# Hudson River Drinking Water Intermunicipal Council

December 1, 2020

Re: Champlain Hudson Power Express - Case 10-T-0139

Source: Imagery - (c) 2010 Microsoft Corporation and its data suppliers.

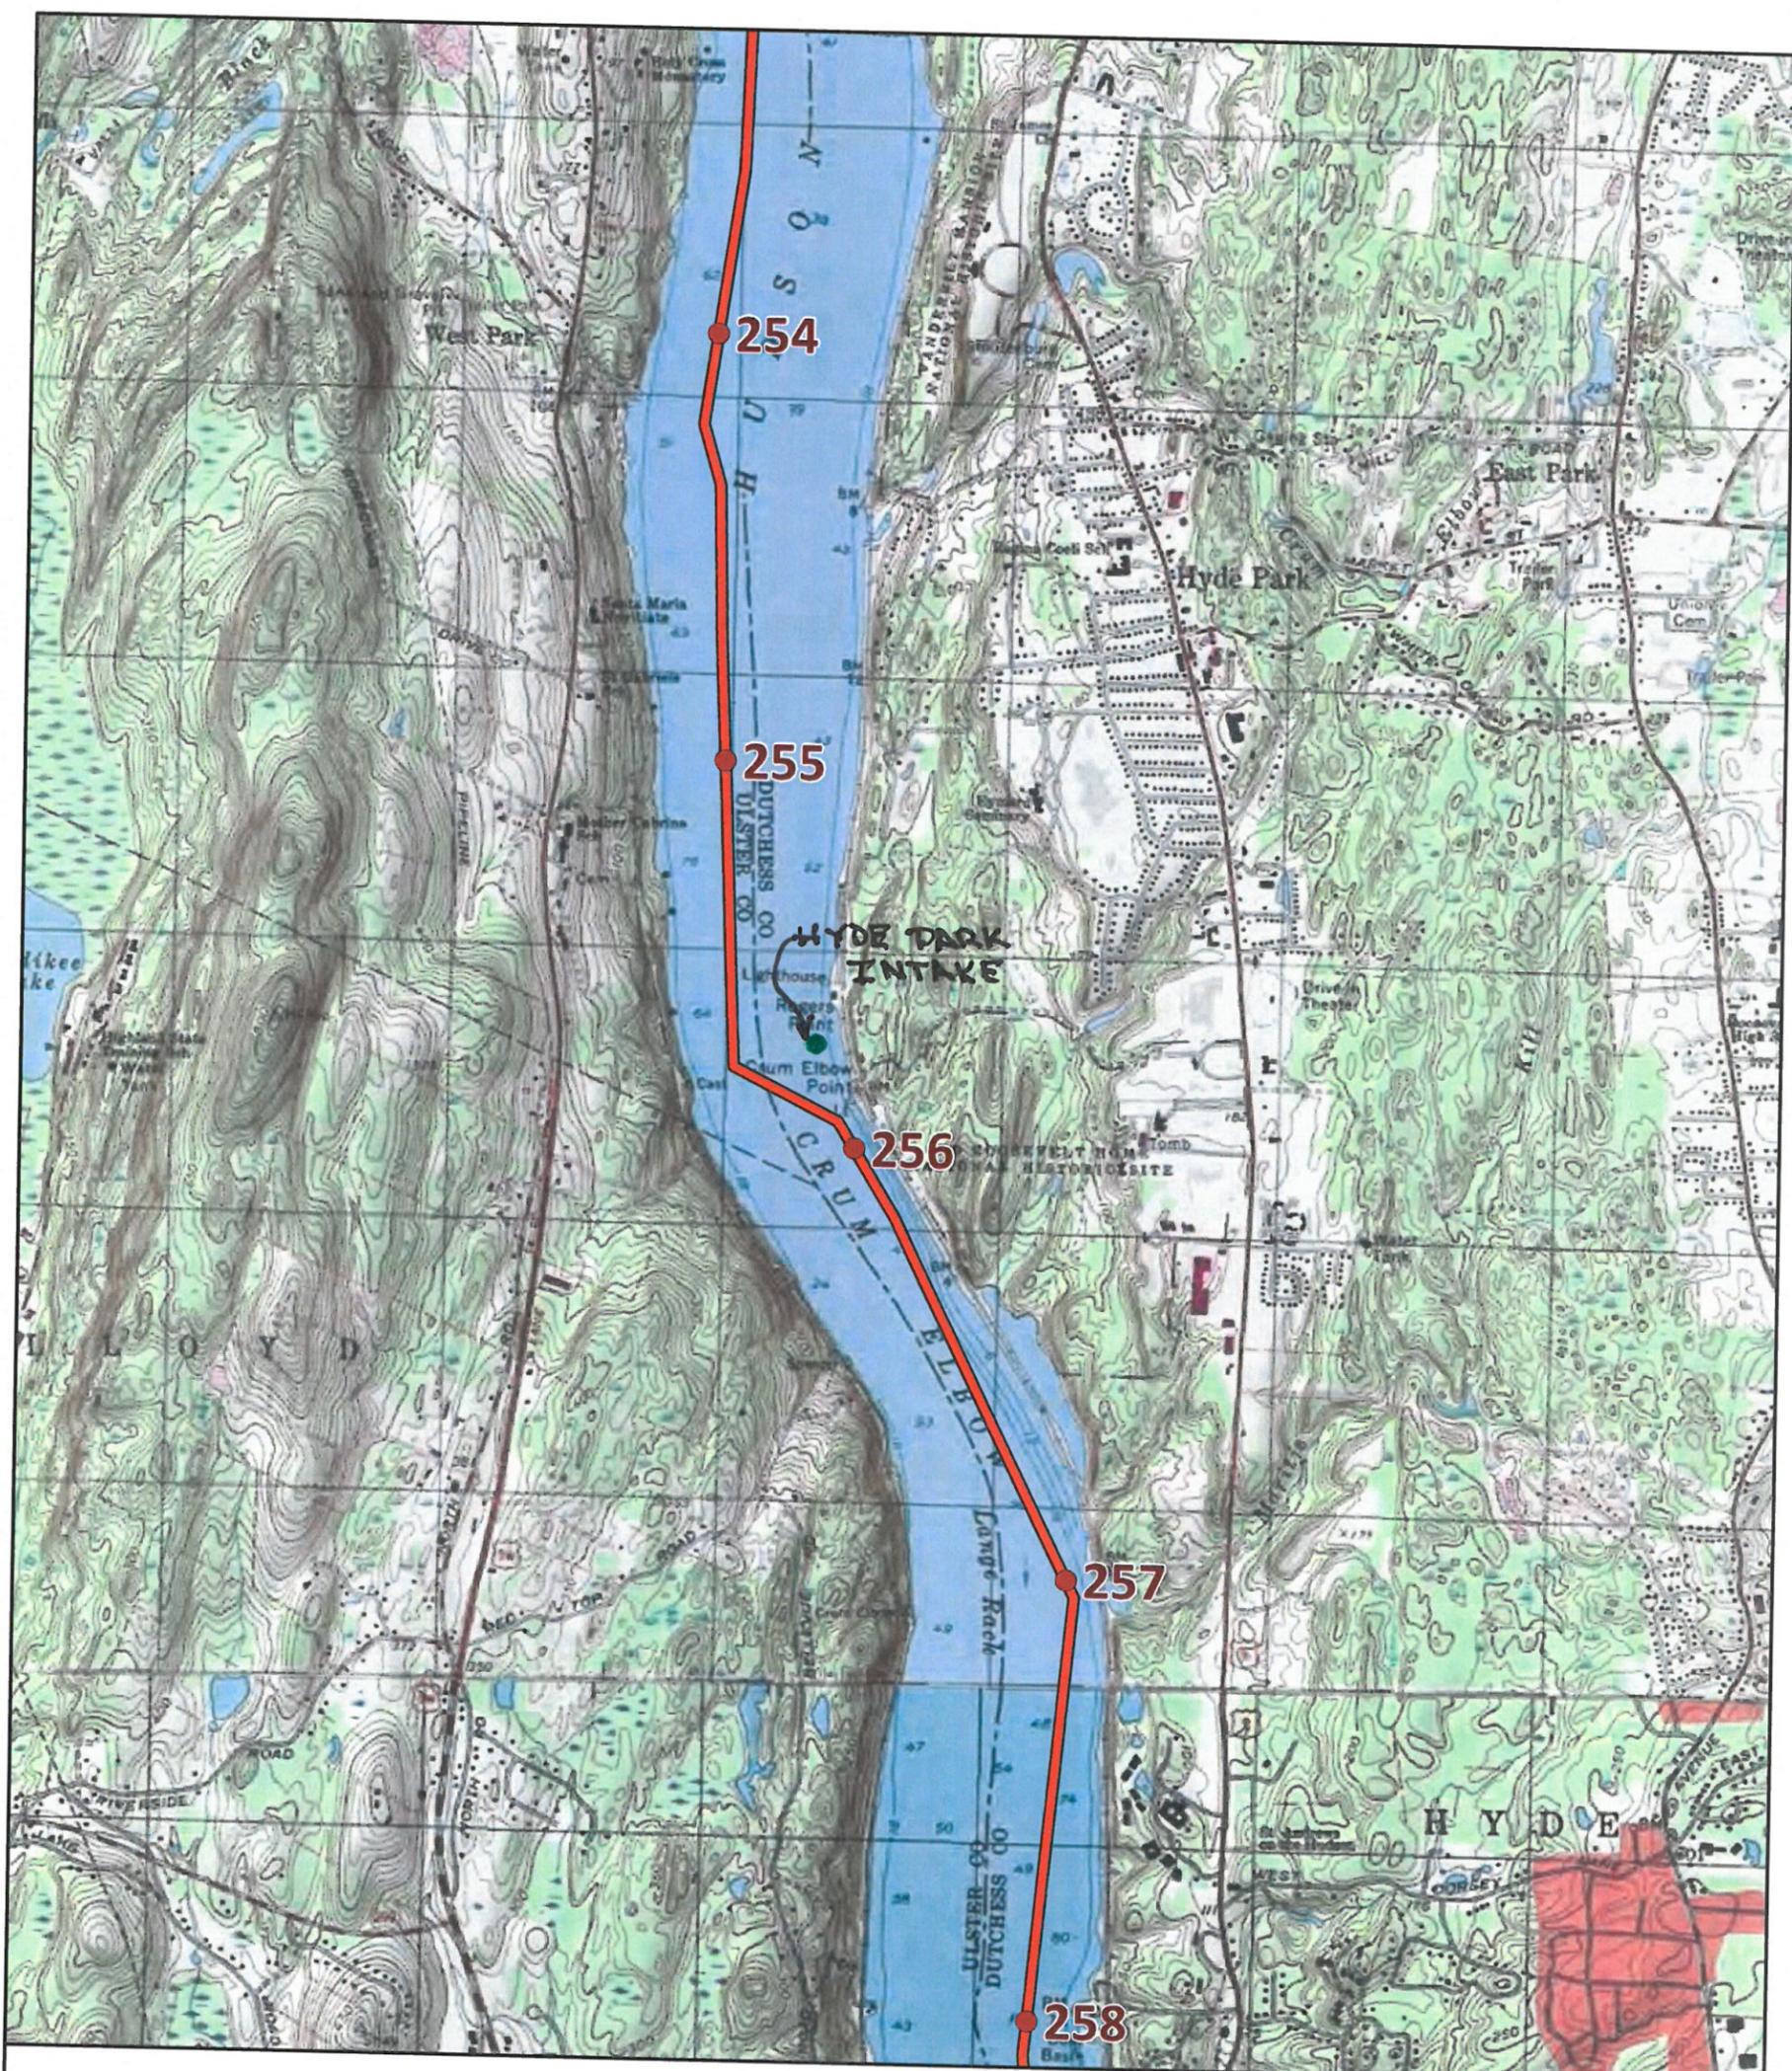
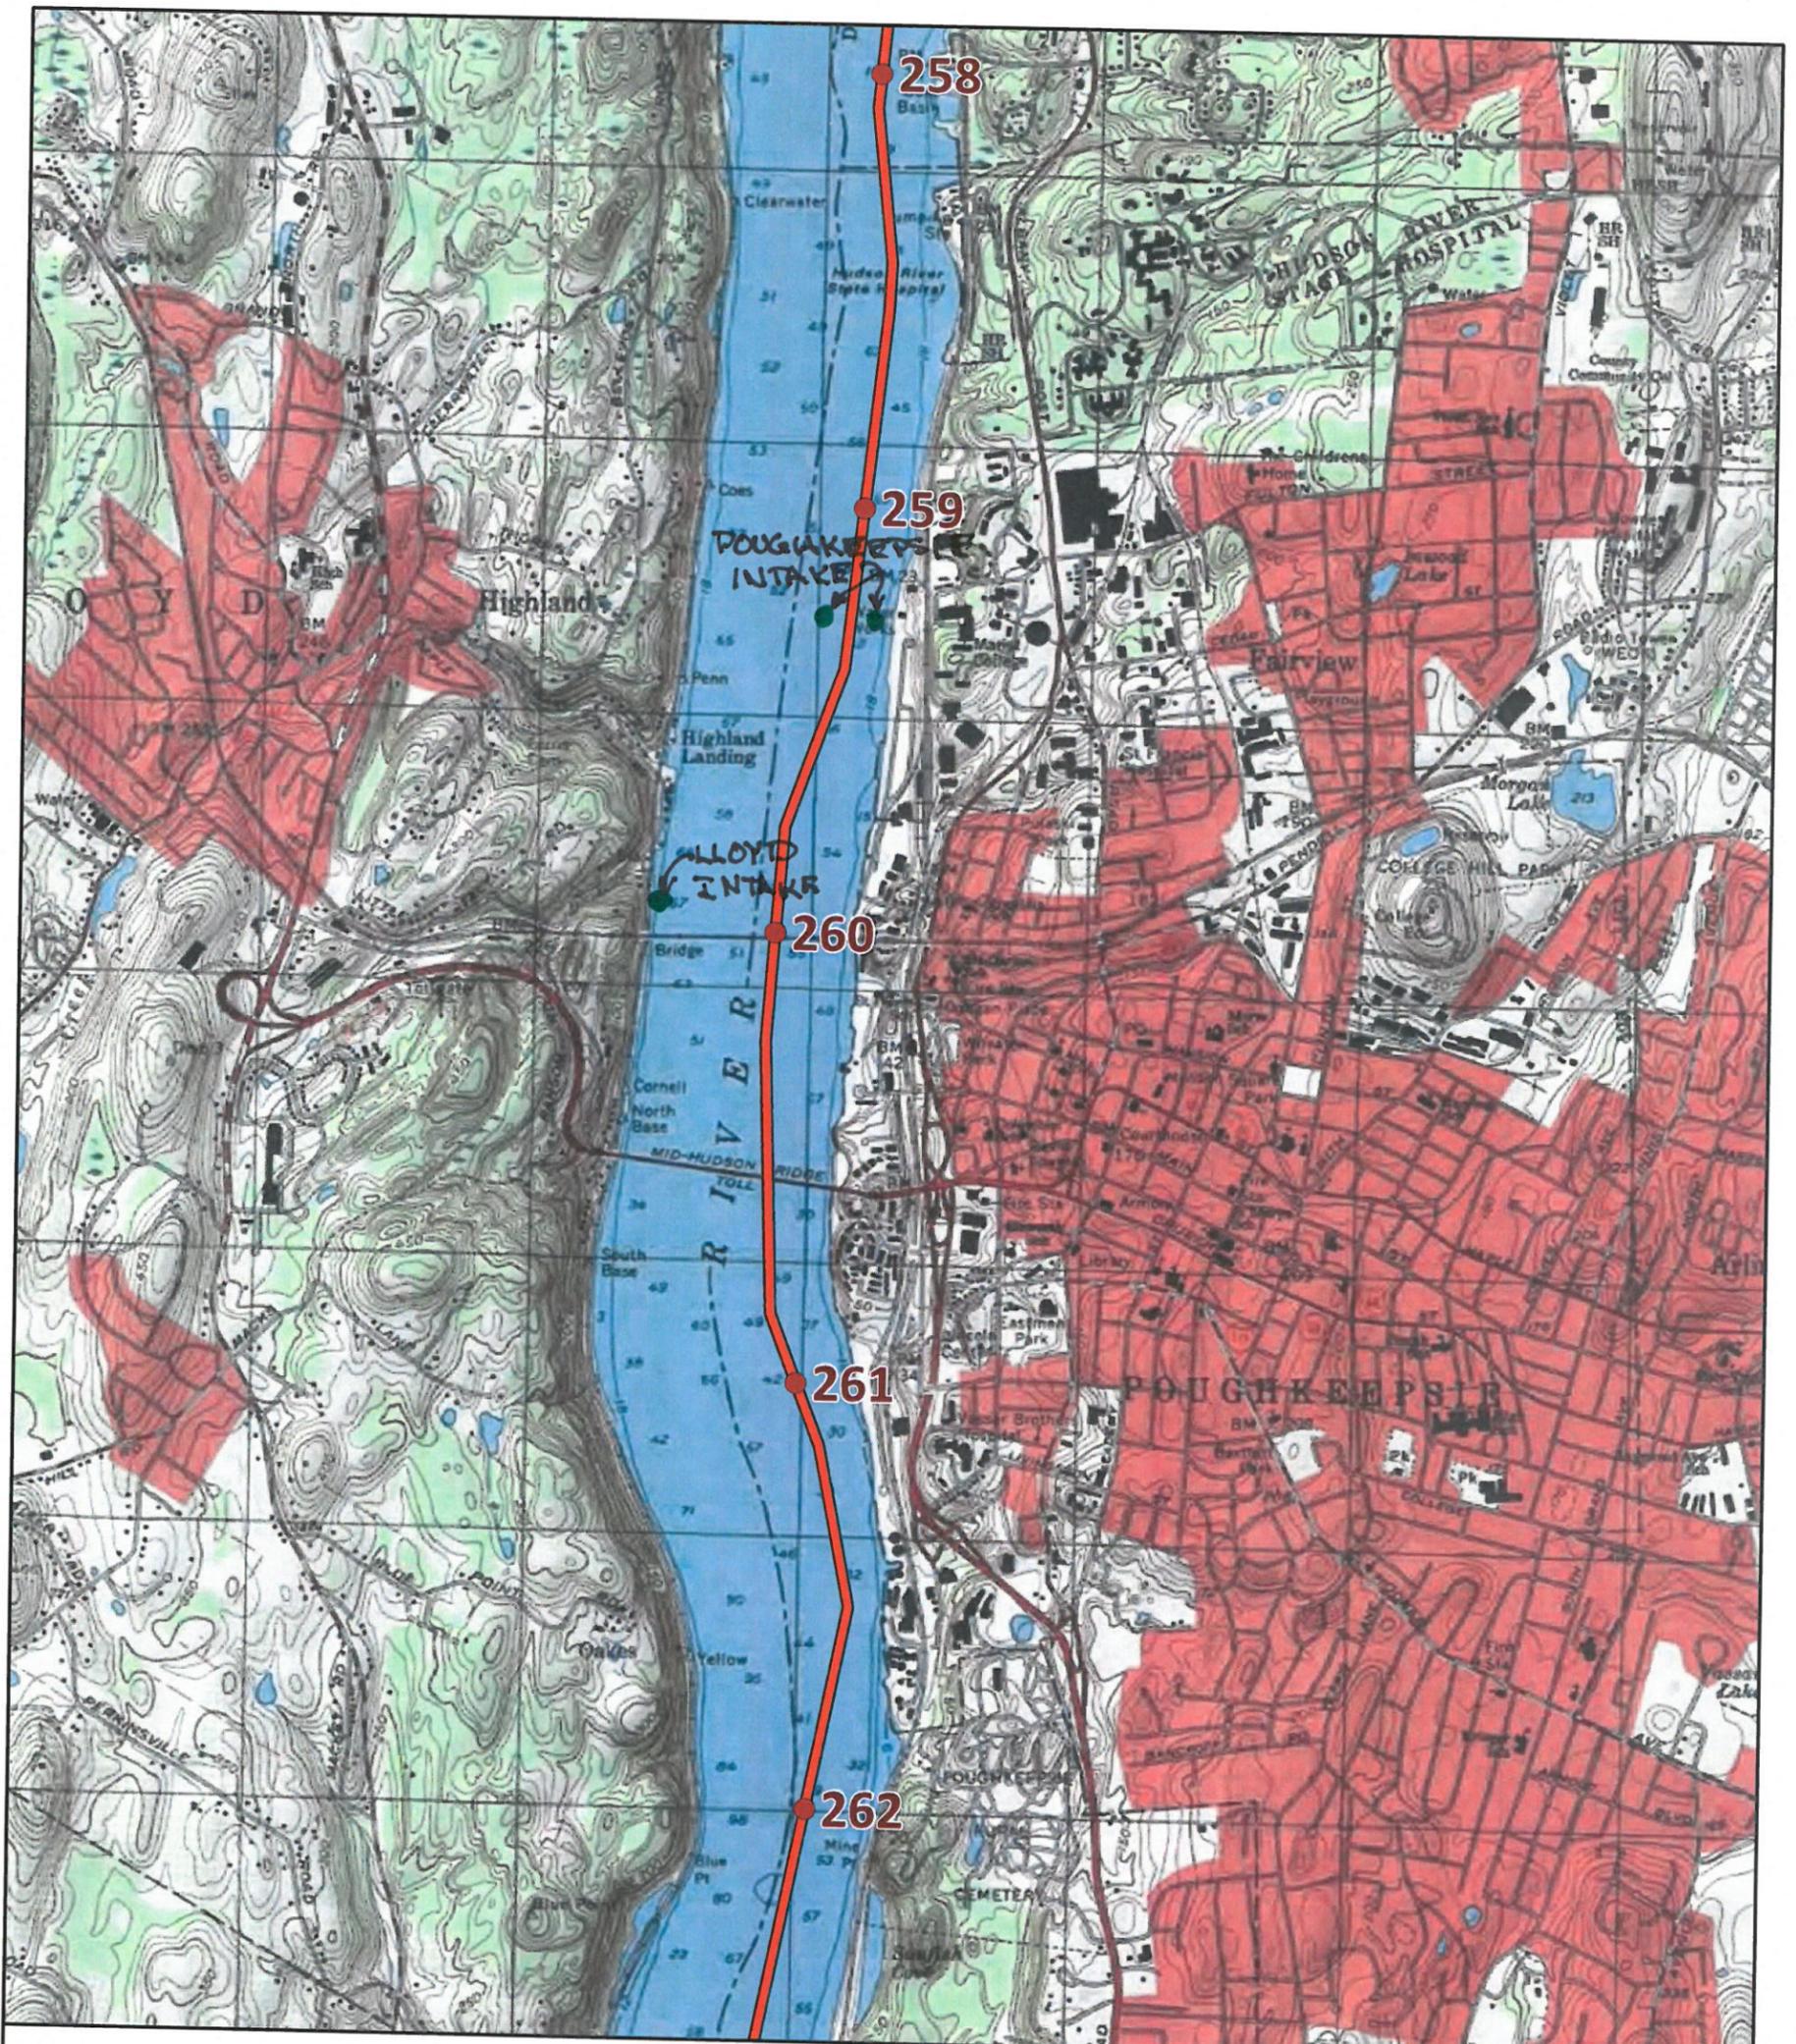
The proposed path of the Project passes within one-half mile of all five of our PWS intakes, as shown on the maps attached as Exhibit A. The cable excavation would be within 500 feet of Esopus's intake and would pass between Poughkeepsie's two intakes. Project documents make no mention of Lloyd's intake. Excavation of the river bottom threatens to suspend contaminated sediments that will be drawn directly into the PWS intakes.

In light of these risks, the most prudent course of action would be to modify the Project to a terrestrial route for the section of the Hudson River affecting drinking water intakes, from at least Kingston to Poughkeepsie. For example, the CSX corridor along the west side of the river could offer an alternative route that would avoid our water intakes completely.
